October 13, 2021

SUBJECT: Conditional Approval of Remedial Action Plan under Wis. Admin. Code § NR 724.09 and Materials Management Plan under Wis. Admin. Code § NR 718.12  
River North, 1000 River Point Drive, Manitowoc, WI 54220  
BRRTS #: 02-36-588366

Figure 13 - Grading Plan and Cut/Fill Areas

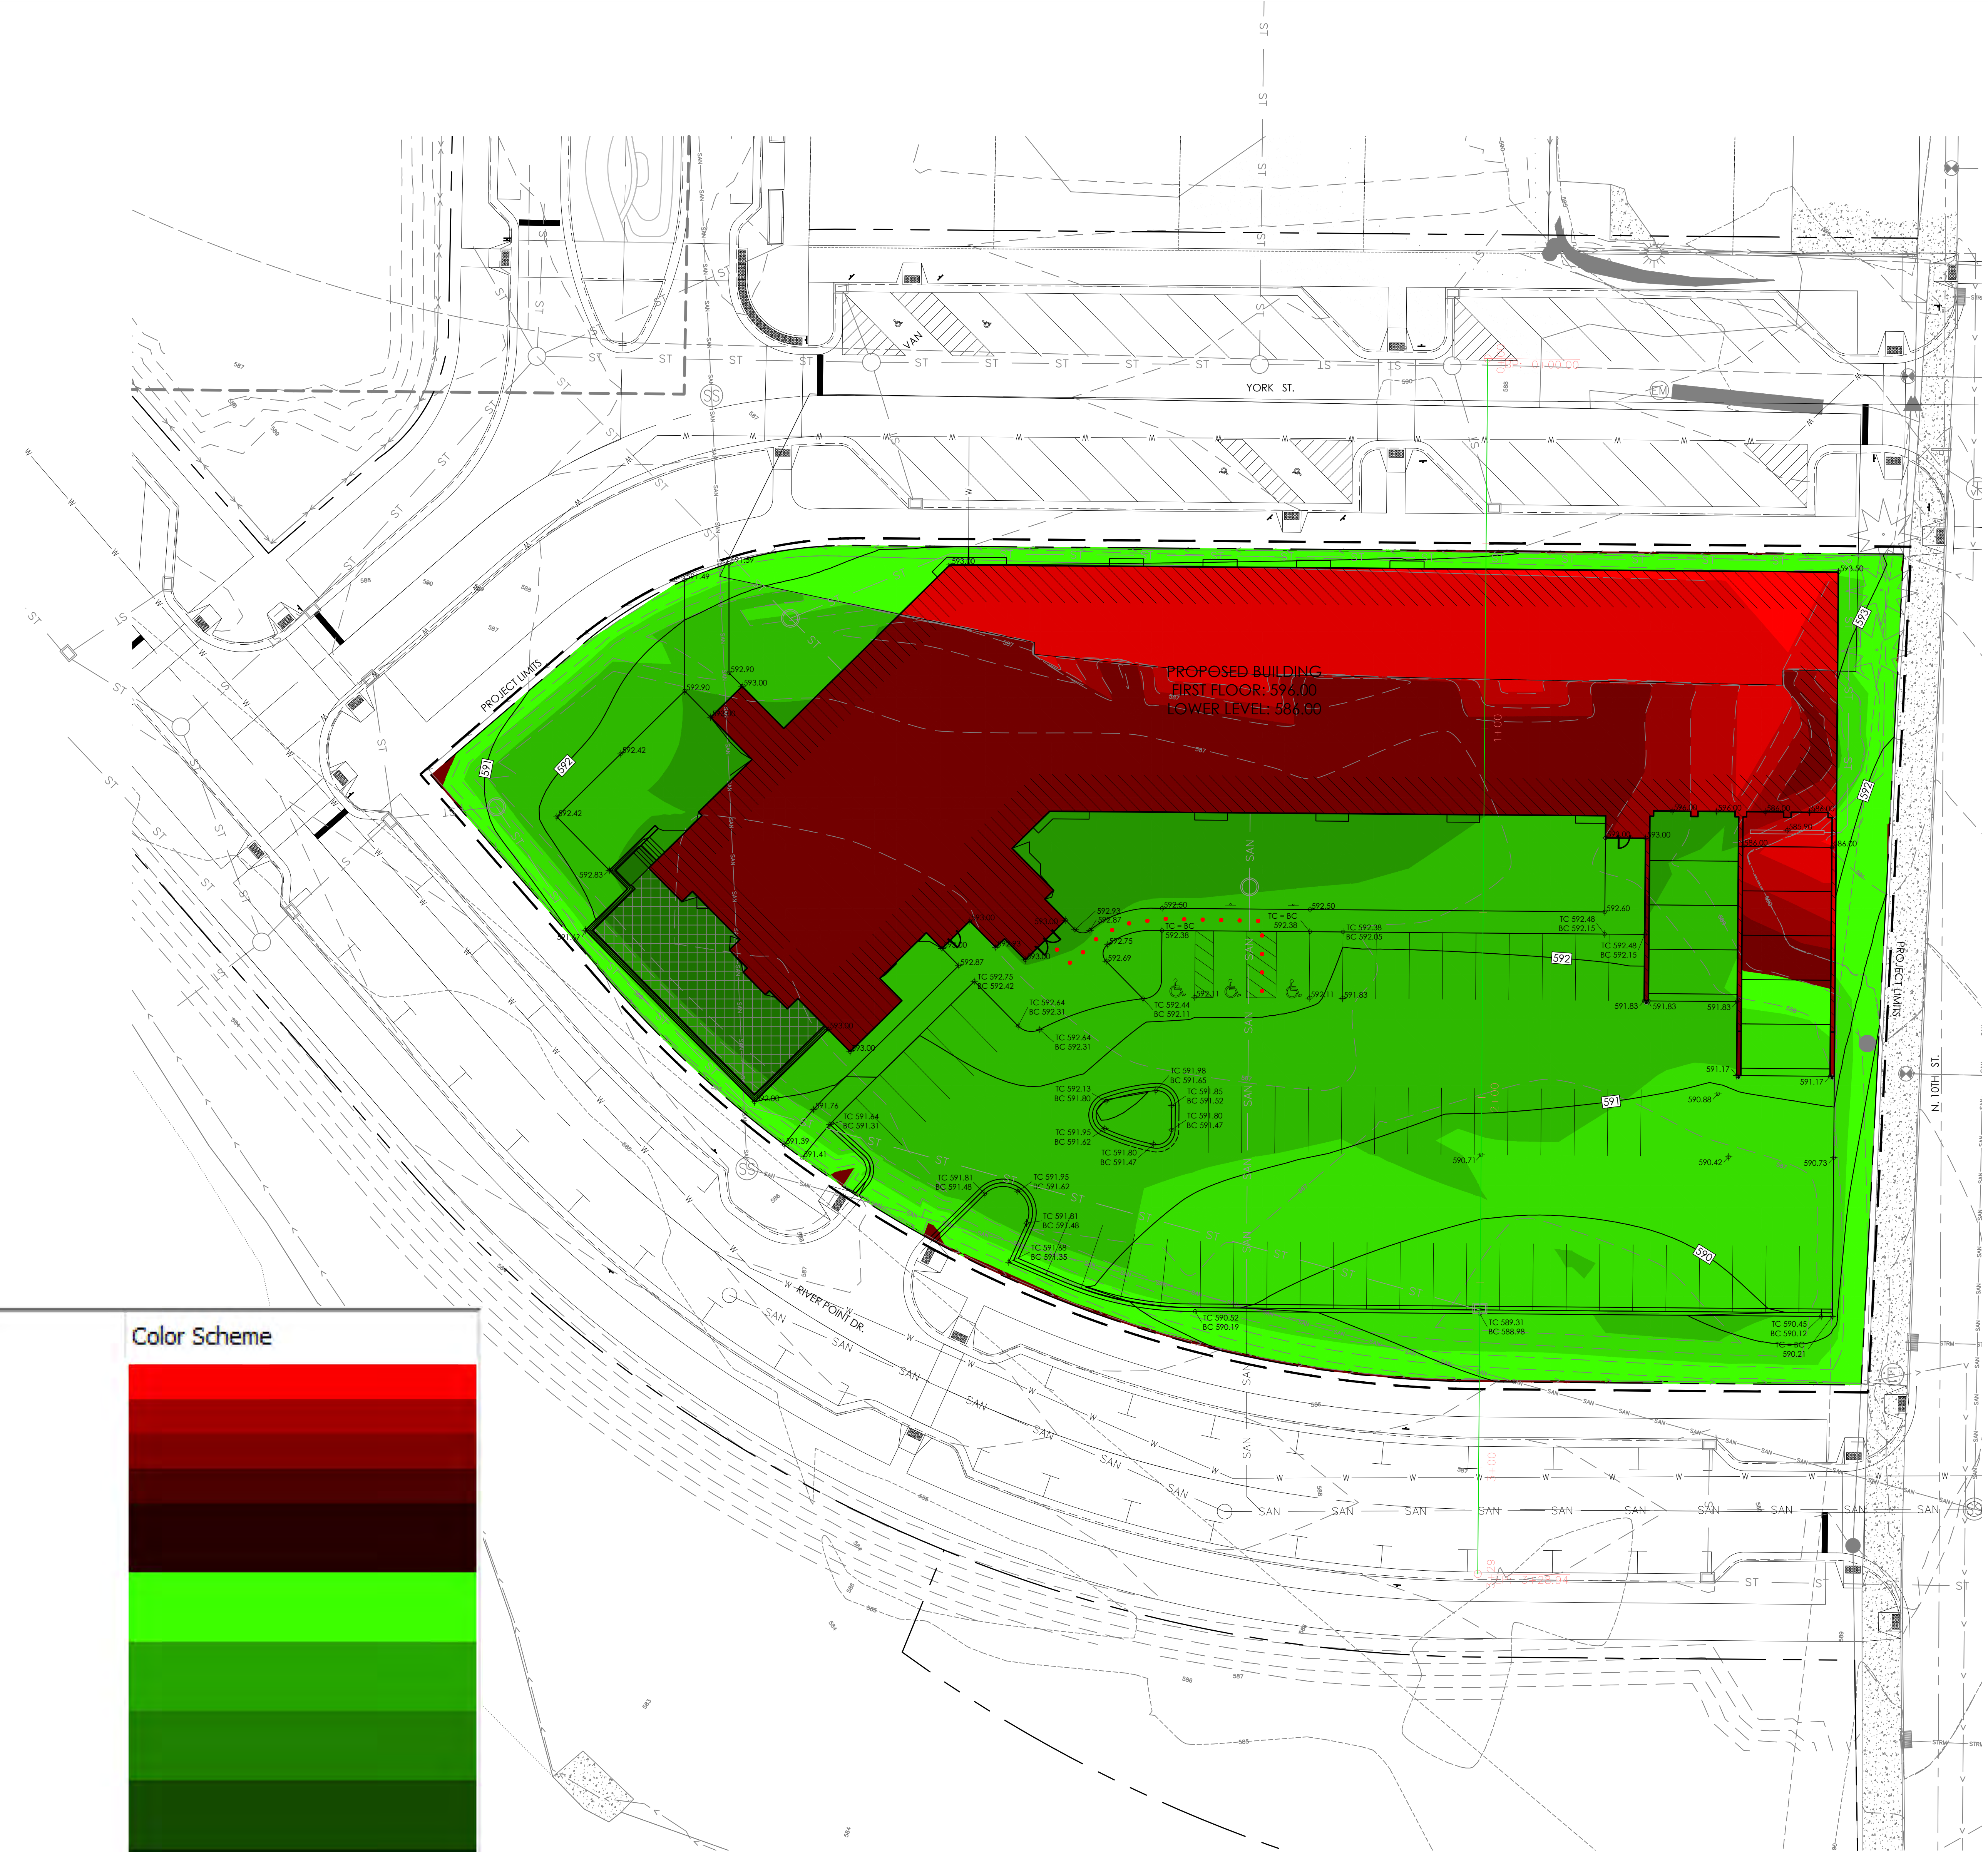
of soil contaminated with PAHs and metals will be reused under the surface parking lot (refer to *Figure 13, Grading Plan and Cut/Fill Areas*, dated May 11, 2021). Approximately 790 cubic yards of soil contaminated with PVOCs + N will be excavated and disposed at a landfill (refer to *Figure 1, Test Pits and Proposed Excavation Extent*, dated April 15, 2021). A vapor mitigation system with vapor barrier, sealed sumps, and a vapor barrier in the elevator shaft will be installed as part of the building construction to address any potential vapor intrusion concerns (refer to *Sheet Number C1.01, Sub Slab Depressurization – Foundation Plan*, dated September 15, 2021). Post-construction vapor sampling from vapor ports installed through the slab and underlying vapor barrier will be completed to determine if the vapor mitigation system needs to be operated to mitigate vapors. A clean clay cutoff wall is also planned to be installed in the utility lateral trench at the property boundary to reduce the risk of potential contaminant migration. Any contaminated water that may be encountered during construction will be properly managed.
